**RECOMMENDATION TO DESIGN REVIEW COMMITTEE**

**CASE FILE NO.:** Z0625-18-D

**PROPOSAL:** Design Review for a multifamily development known as “Heirloom” on 13 acres of land between Luther Road and Johnson Creeks Road adjacent to Johnson Creek. Proposed development consists of 286 dwelling units, in ten buildings with 439 parking spaces, and clubhouse with leasing office and associated site improvements including site access, circulation, landscape, and infrastructure. There is concurrent review of a Habitat Conservation Area Map Verification Z0086-19 and Habitat Conservation Area Development Permit Z0141-19 addressing development within the HCA area associated with Johnson Creek.

**Site Plan Detail of Johnson Creek and HCA Area as it related to development**

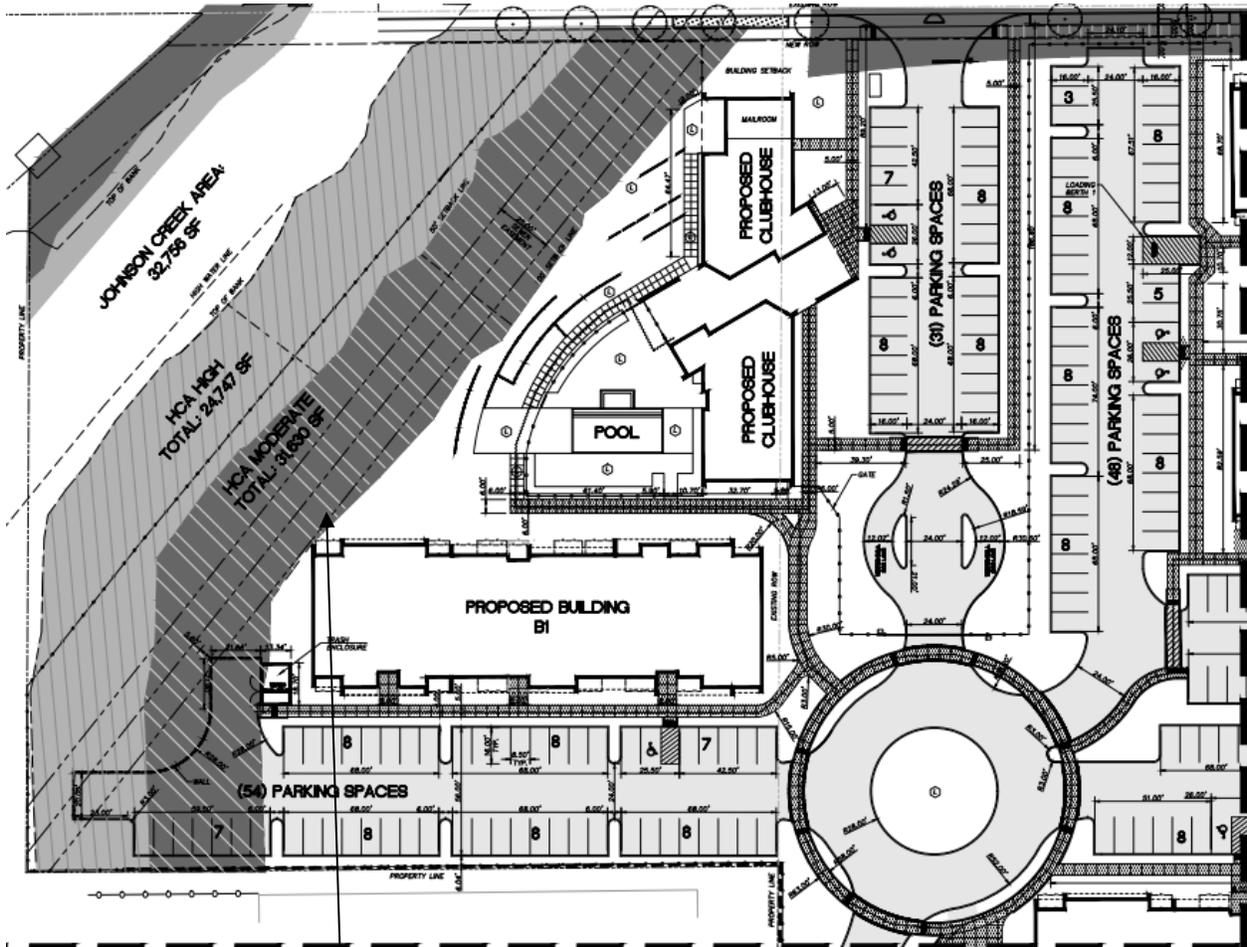
- a. Provide verification from the City of Portland Bureau of Environmental Services authorizing the proposed development over the 20 foot exclusive Lents Sewer main easement is allowable or modify the site plan as required to comply with the City of Portland easement requirements.

- b. No deep rooting large trees as outlined in the landscape plan can be planted within the 20 foot Lents Sewer Main easement.
- c. Submit additional information and a revised landscaping plan to detailing the proposed landscape buffering or screening to demonstrate compliance with ZDO 1009.04(A), (B), and (C) and 1005.04(J). City of Portland Lents Sewer easement Z0086-19 MV and Z0141-HD conditions of approval.
